TOLEDO - LUCAS COUNTY PLAN COMMISSIONS

REF: PUD-11007-23
DATE: January 11, 2023

SUBJECT: Amendment to Planned Unit Development granted by Ord. 550-12, 87-17, 30-21 and 611-22

Request	-	Amendment to Planned Unit Development granted by Ord. 550-12, 87-17, 30-21 and 611-22.
Location	-	801 Division Street Toledo OH 43606
Applicant + Owner	-	Lucas County Metropolitan Housing 424 Jackson Street Toledo, OH 43604
Architect	-	Ray Micham The Collaborative One Seagate 550 N Summit Street, Level 118 Toledo, OH 43604
Engineer	-	Lewandowski Engineers 234 N. Erie Street Toledo, OH 43604

SITE PLAN - MAGNIFIED

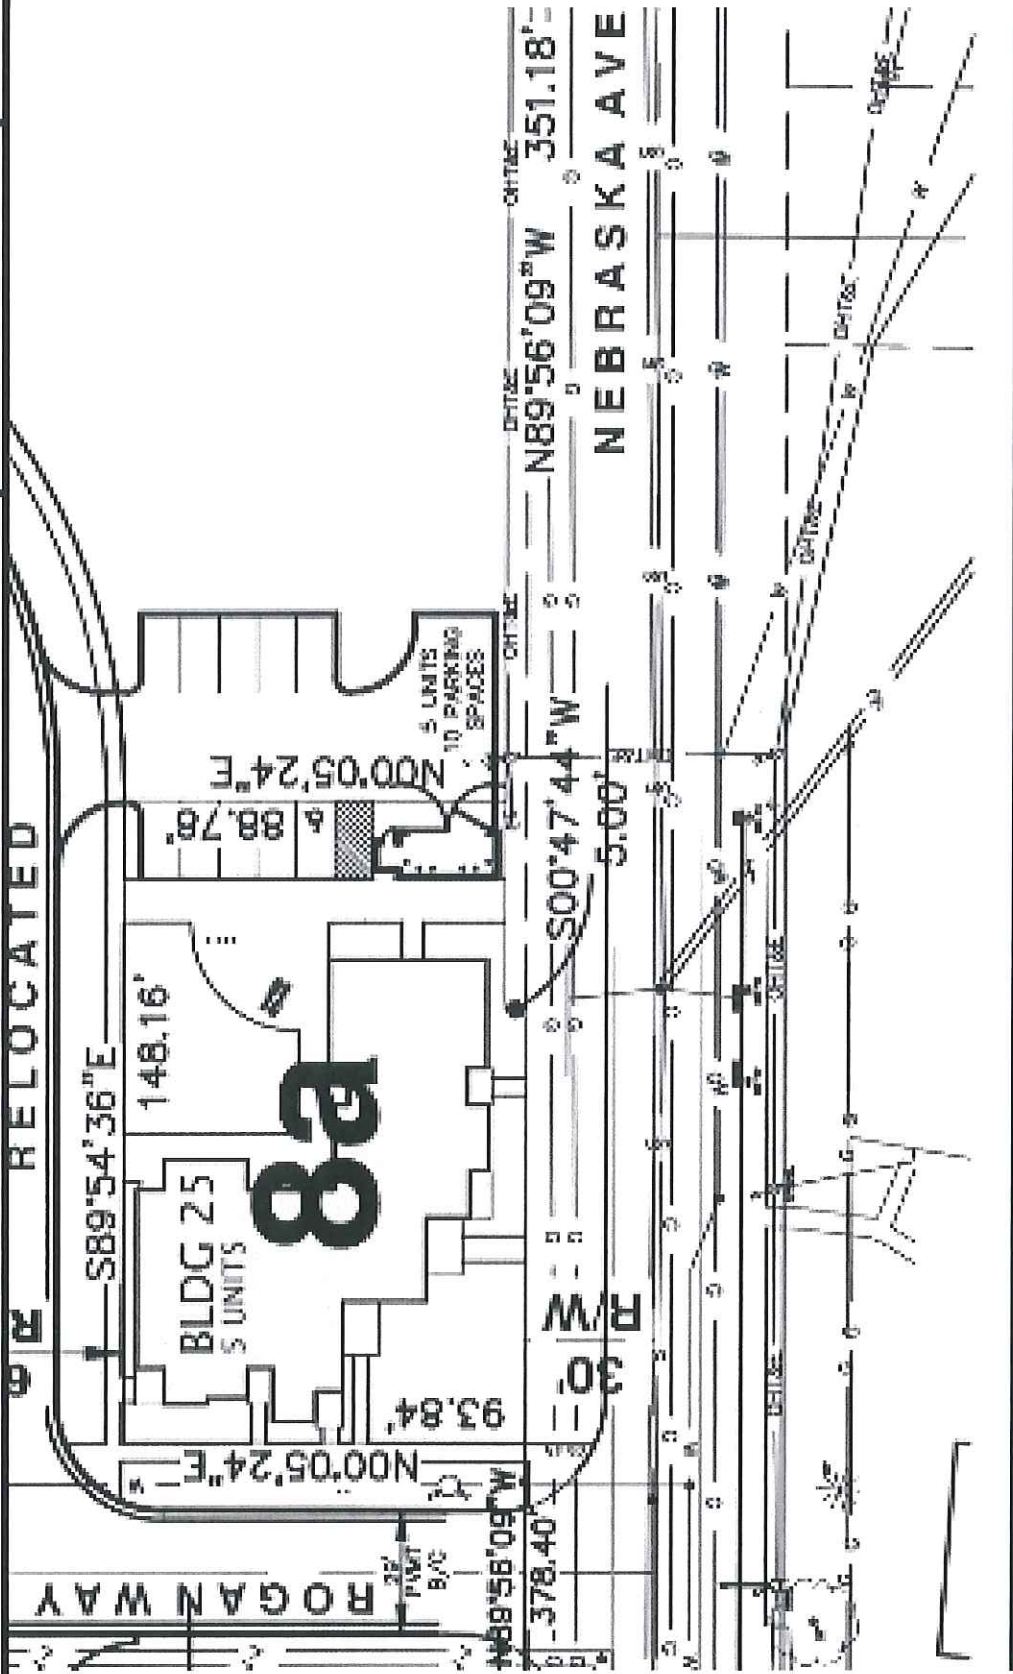
35. Off-street parking shall be provided pursuant to Off-Street Parking Schedule "A," (TMC§1107.0304). Minimum number of off-street parking spaces required for multi-family housing is one (1) and one-half (1 ½) spaces for every one (1) dwelling unit, plus one (1) space per ten (10) units for visitor parking. A total of nine (9) parking spaces is required for the use. The submitted site plan shows ten (10) parking spaces. **Acceptable as depicted on submitted site plan.**

36. Bicycle parking slots shall be provided pursuant to Off-Street Parking Schedule "A," (TMC§1107.0300). Minimum number of bicycle parking slots required for a multifamily housing is one (1) bicycle parking per ten (10) parking spaces. Four (4) bicycle parking spaces are indicated on the submitted site plan. **Acceptable as depicted on submitted site plan.**

37. Any spaces reserved for the use by persons with physical disabilities shall adhere to the standards outlined in TMC§1107.1700. One (1) van accessible space with an eight-foot (8') drive aisle is required. **Acceptable as depicted on submitted site plan.**

LANDSCAPE PLAN

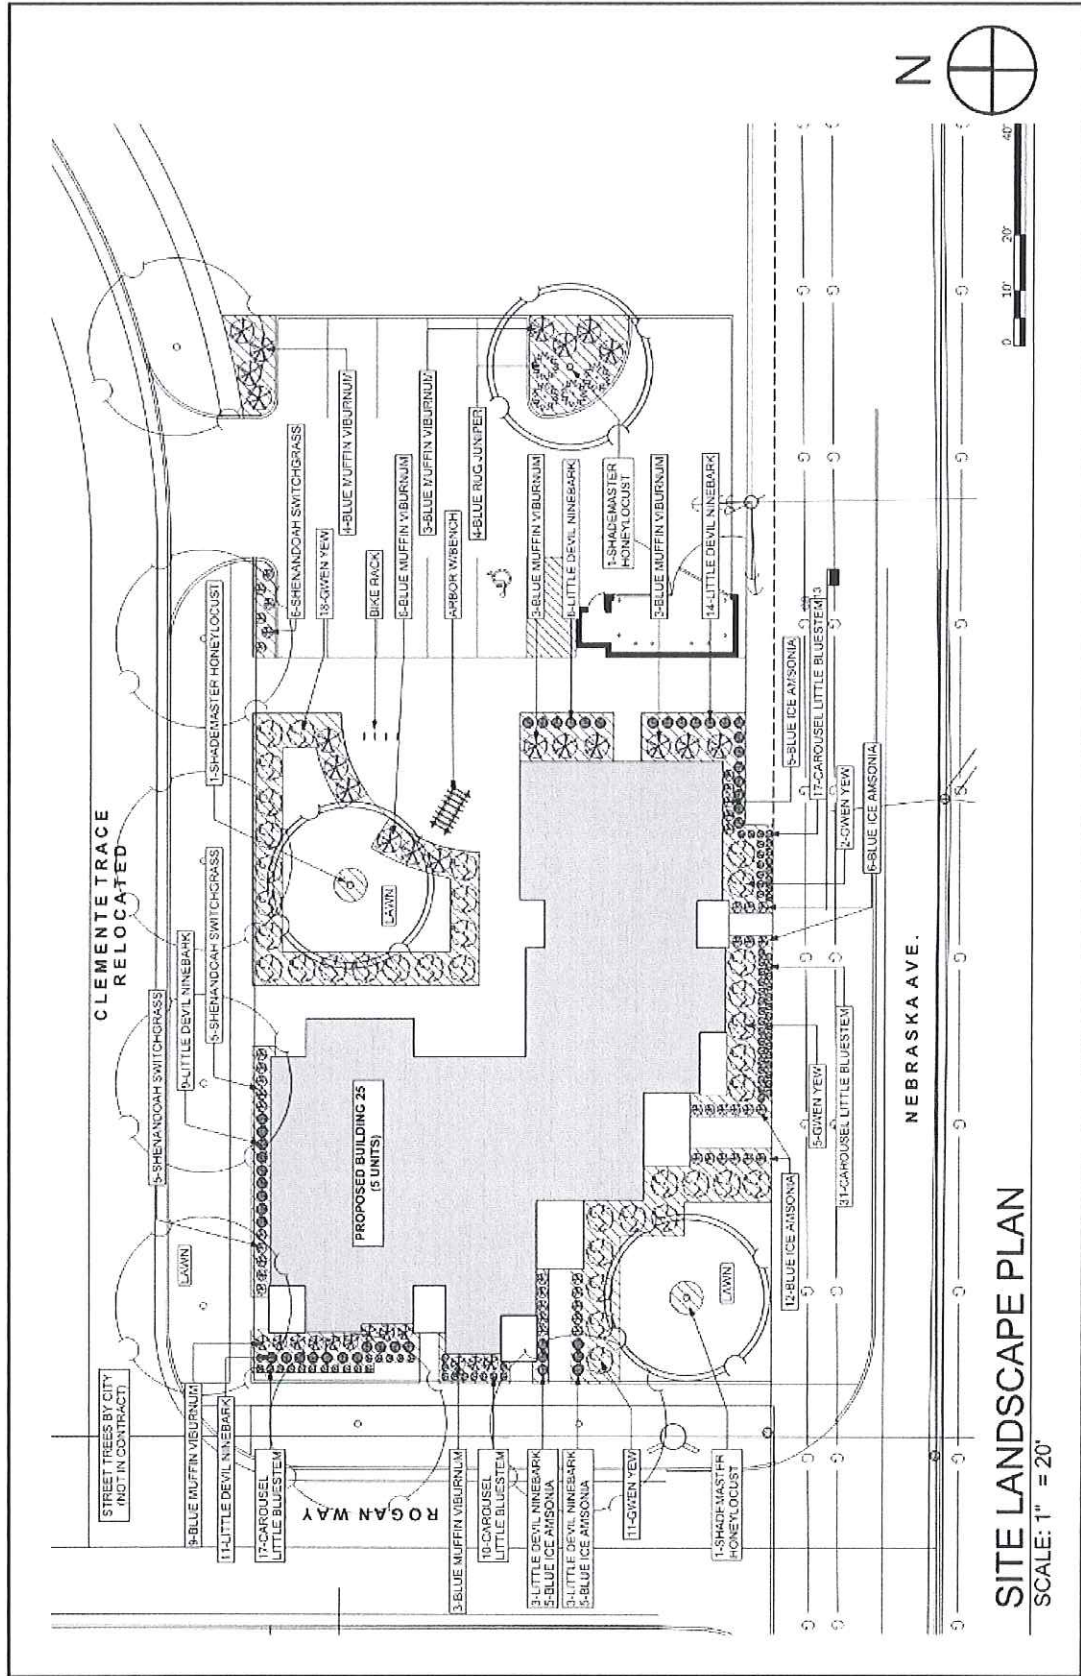
In addition to that, the total interior landscaping required for parking lots is twenty (20) square feet per parking space. The site's parking lot contains a total of ten (10) parking spaces, which requires a minimum of 200 square feet for interior parking lot landscaping. Additionally, two (2) canopy trees and six (6) shrubs are required to be installed in interior landscape areas for each ten (10) parking spaces. A total of two (2) trees and six (6) shrubs are required in the interior parking. This is acceptable as depicted on the submitted landscaping plan.

Finally, one (1) tree per 500 square feet of building coverage, or fraction thereof, is required for all structures. Additionally, foundation plantings and landscaping at major building entrances are required. The submitted landscape plan shows the required interior site landscaping throughout the site and along the building foundations.

- a. A fifteen-foot (15') frontage greenbelt buffer is required along Nebraska Avenue, Rogan Way and Clemente Trace. At least one tree must be provided for every 30 feet of lot frontage or fraction thereof. The frontage greenbelt shall also include a solid evergreen hedge to screen parking in the front of the property and prevent headlights from being seen from the right-of-way. The submitted site plan shows an eight-foot (8') buffer along Nebraska Avenue and a portion of Rogan Way. A three-foot (3') buffer is also shown along Clemente Trace. Five (5) and three (3) trees are indicated in the greenbelt buffer along Clemente Trace and Rogan Trace respectively. **Not acceptable as depicted on landscaping plan. Applicant shall obtain approval to a waiver from TMC§1108.0202(B)(3);**

- d. One 2-inch caliper tree for every 5,000 square feet of building coverage shall be required. Five (5) trees are required for this site. **Not acceptable as depicted on landscaping plan. Applicant shall provide square footage of proposed building to determine required number of trees.**

Approve a waiver to reduce required frontage greenbelt buffer to eight feet (8') along Nebraska Avenue and a portion of Rogan Way and three feet (3') buffer along Clemente Trace due to limited space.
